**Reply of VGB at the ENTSO-E presentation
dated 12/6/2018 and entitled
“ENTSO-E responses to VGB important items
from 03.03.2018 GC ESC”**

Presented at GC- ESC 14/9/2018

FRT specifications

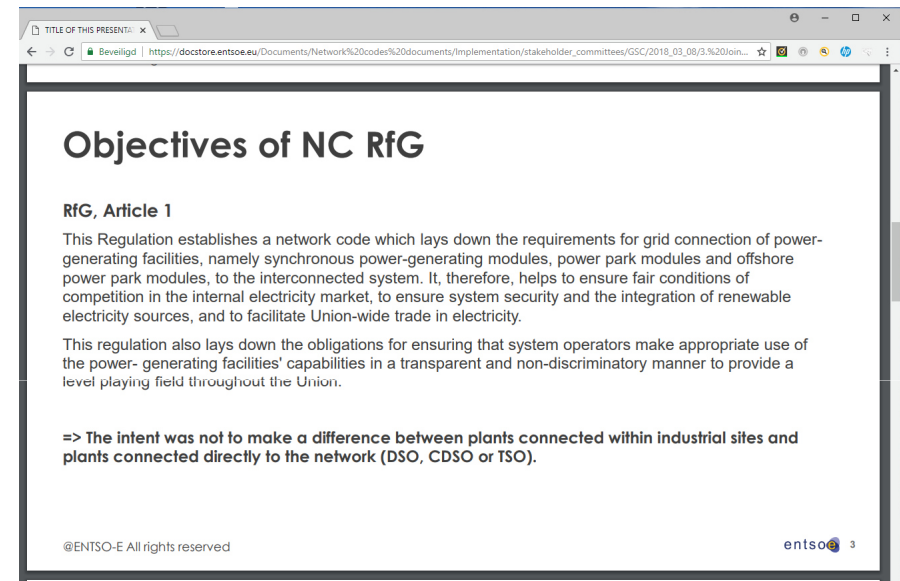
So market distortion is possible for Member States imposing values above 0,15 sec

Is such distortion consistent with the EU view to ensuring the proper functioning of the internal market in electricity as specified in Recital 2 of the RfG code?
